File #:	O2023-1551				
Туре:	Ordi	inance	Status:	Recommended for Passage	
File created:	4/19	0/2023	In control:	Committee on Transportation and Public Way	
			Final action:		
Title:	Approval of plat of Collection of McCormick Square Resubdivision				
Sponsors:	Dowell, Pat, King, Sophia D.				
Indexes:	Resubdivision				
Attachments:	1. O2023-1551.pdf				
Date	Ver.	Action By	A	ction Result	
6/13/2023	1	Committee on Trans Public Way	portation and		
4/19/2023	1	City Council	R	eferred	
		SUE	BDIVISION O	RDINANCE

Re: Proposed Subdivision Ordinance 3rd and 4,h Wards

OUC File No. VD-108179 M&P Project No. 22/27-3/4-21-3962 Water Atlas Pages 332, 332PK, 345, 345PK, 359 Sewer Atlas Pages 39-2-16, 39-2-12, 39-1-13, 39-1-09, 39-1-10

EXHIBIT "A"' €»©5,I©®tfL©£6. at \$®©€5@£iiE&?LeSe S«|^a??© K©safe«HLv;!sai©ii. &ciNu \* mwjsemjioh iujm>0.s 22 anoifcr-m 27, tgwnsw."-vo north, funge m fast of 7mr third principal meridiam, in cook county, iiunois

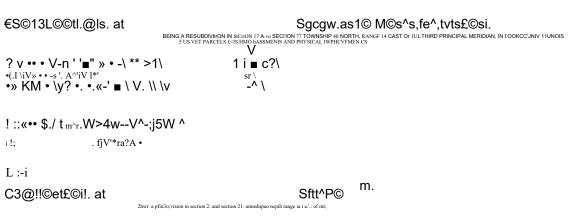
There are extensive public water facilities within the limits of the areas proposed for subdivision. These include water mains within current public ROW that will remain public ROW and water mains installed within lots platted as part of the subdivision.

There are the following water mains, valves, hydrants and other water main appurtenances in the following locations within the subdivision:

- 1. Lot 3: Approx. 1,000' of 36" water main at various locations;
- 2. Lot 4: Approx. 650' of 24" water main near the east line of Lot 4 and approx. 825' of 24" water main near the west line of Lot 4;
- 3. Lot 5: Approx. 125' of 24" water main near the east line of Lot 5 and approx. 120' of 24" water main near the west line of Lot 5;
- 4. Lot 6; Approx. 2940' of 24" water main near the east, west and north sides of Lot 6;
- 5. Lot 7: Approx. 160'of 24" water main near the east line of Lot 7;
- 6. Lots 9 and 10; Approx. 200' of 24" water main along the south line of Lot 9 and north line of Lot 10;

7. Lots 12, 13, 14 and 15: Approx. 700'of 24" water main and 2,920'of 12" water main in various locations in these lots;

8. Lot 19: Approx. 1520' of 24" water main in vacated S Prairie Avenue between

E Cermak Road and E 24th Place and 230' of 36" water main in the southeast comer of Lot 19

The Plat of Subdivision dated September 9, 2022 shows easements reserved for water. The easements are subject to the conditions in Section III.

Per Exhibit "A" titled McCormick Subdivision, there is a total of twenty-three (23) proposed lots represented as Lot 1 through Lot 23.

PUBLIC SEWERS TO BE MAINTAINED BY THE CITY: Based on sewer records, the following public sewers and associated structures are present within the area proposed for subdivision. These sewers must be retained and maintained.

1. Lot 1: Approx. 250' of 42" sewer from approx. E 30th St to E 31st St.

2. Lot 1: Approx. 660' of 96" sewer from approx. E 29th PI to approx. E 30th St.

- 3. Lot 6: Approx.470' of 150" sewer tunnel on E Cermak Rd from S McCormick PI Busway to LSD.
- 4. Lot 7: Approx. 100' of 24" sewer on approx. E 17th St from S LSD to 100' west of S LSD.
- 5. Lot 7: Approx. 950' of 24" sewer along S LSD from approx. 530' south of E 18th St to approx. 375' north of E 18th St.
- 6. Lot 12: Approx. 80' of 150" sewer tunnel approx. 20' south of the north line of Lot 12 from the east line of Lot 12 to the west line of Lot 12.
- 7. Lot 12: Approx. 90' of 72" sewer approx. on S Cermak Rd from vacated S MLK Dr to S McCormick PI Busway.
- 8. Lot 15: Approx. 330' of 150" sewer tunnel on E Cermak Rd approx. from S MLK Dr to S McCormick PI Busway.
- 9. Lot 15: Approx. 320' of 72" sewer on E Cermak Rd on the northern line of Lot 15 from the east line of Lot 15 to the west line of Lot 15.

PRIVATE SEWERS TO BE MAINTAINED BY METROPOLITAN PIER AND EXPOSITION AUTHORITY (MPEA): Based on sewer records, the following sewers are serving private properties within the area proposed for subdivision. To approve the proposed subdivision, the beneficiary must assume ownership of these sewers and appurtenances along with any existing flow, which may exist from the area outside of the proposed subdivision. These sewer facilities will be private property of the beneficiary. The beneficiary must

unic an naonn	y for these facilities and be responsible for an maintenance and repairs for reuse.
1.	Lot 6: Approx. 400' of 48" sewer on approx. H 21st St from LSD to the west line of Lot 6.

2.	Lot 9: Approx. 120' of 12" sewer on approx. E Cermak Rd east from S McCormick PI Busway
3.	Lot 13: Approx. 10' of 27" sewer from 10' east of the west line of Lot 13 to the west line of Lot 13.

4.	Lot 13: Approx. 10'of 24" sewer from 10' east of the west line of Lot 13 to the west line of Lot 13.
5.	Lot 17: Approx. 140' of 24" sewer on vacated E 23rd St from vacated S Prairie Ave to S MLK Dr.

6.	Lot 18: Approx. 230' of 24" sewer on vacated E 23rd St from vacated S Prairie Ave to S MLK Dr.
7.	Lot 19: Approx. 1670' of 12" sewer on vacated S Cottage Grove Ave from S Indiana Ave to E 24lh PI.

8.	Lot 19: Approx. 250' of 12" sewer on vacated E 23rd St from S Indiana Ave to vacated S Cottage Grove Ave.
9.	Lot 19: Approx. 150' of 24" sewer on vacated E 23rd St from vacated S Cottage Grove Ave to vacated S Prairie
Ave.

10.	Lot 19: Approx. 570' of 30" sewer on S Prairie Ave from E Cermak Rd to E 23rd St.
1 1. Lot 19:	Approx. 370' of 24" sewer on S Prairie Ave from vacated 23rd St to vacated S Cottage Grove Ave.

12.	Lot 19: Approx. 270' of 12" sewer on S Prairie Ave from vacated S Cottage Grove Ave to 24th St.
13.	Lot 19: Approx. 350' of 24" sewer on vacated S Prairie Ave from 24th St to 24lh PI.

14.	Lot 19: Approx. 400' of 12" sewer on vacated E 24th St from S Indiana Ave to vacated S Prairie Ave.
15.	Lot 19: Approx. 260' of 24" sewer on vacated E 24th St from vacated S Prairie Ave to vacated S Cottage Grove
Ave.

16.	Lot 19: Approx. 160' of 12" sewer on E 24,h St from vacated S Cottage Grove Ave to S MLK Dr.
17.	Lot 19: Approx. 310' of 24" sewer on approx. S Calumet Ave from vacated E 24th St to E 24,h PI.

The Department of Water Management (DWM) will approve the proposed subdivision, provided all existing easements for the above sewer and water facilities must remain. For any sewer and water facilities listed above without an existing easement, the beneficiary must agree to provide new easements with the conditions below:

a) For sewers with a diameter of 42" and smaller, there must be a reservation forty (40) feet wide centered at the centerline of the existing public sewer. For sewers with a diameter of 48" and larger, there must be a reservation sixty (60) feet wide centered at the centerline of the existing public sewer.

b) For all water mains, there must be a reservation forty (40) feet wide centered at the centerline of the existing water main.

c) There must be a minimum of forty (40) feet of vertical clearance from ground level to provide access to construction machinery that would be necessary in the event of a break or if maintenance or relocation were required in the

future. For locations under existing structures, the easement must extend vertically to the existing structure above.

- d) No temporary or permanent buildings or other structures shall be erected upon or over the areas where reservations are required.
- •e) The DWM must have continuous 24-hour access without any obstructions like fences or bollards to the area where the reservations are required.

- 0 It is the beneficiary's responsibility to maintain proper drainage in the areas where reservations are required.
- g) All proposed plans for improvements must be submitted to and approved by the DWM prior to construction.

- h) The beneficiary of the proposed subdivision where the reservations are required must be responsible for the repair, renewal, or replacement of the physical improvements on the areas to be reserved, which may be damaged in connection with the maintenance and repair, or replacement of the sewer facilities and appurtenances.

- i) Any adjustments to DWM facilities in the areas where reservations are required must be paid by the beneficiary.
